Access Compliance Report

Public Rights-of-Way

(Curb Ramps)

Intersection ID: 24484	Main Street: SAINTFIELD_PL	Cross Street: SWINFORD_PL	Location: SW
ADA ID: 935C3546F2AD	Ramp Type: Perp	Initial Pass/Fail: Pass	Overall Compliance: No
		Severity Score: 7.5

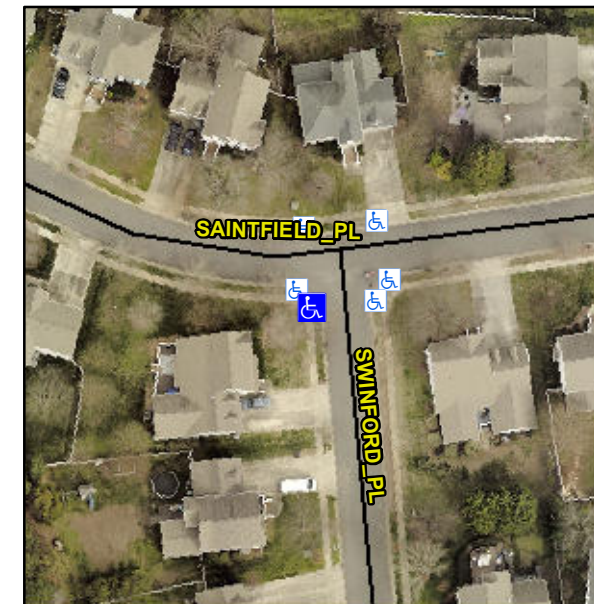
**Not Found, R304.2.2-Perp, R304.3.2-
Para, R305.1.4, R305.2, R302.7,
R304.5.4**

**Remove & Replace Entire Ramp.
Remove & Replace Gutter.**
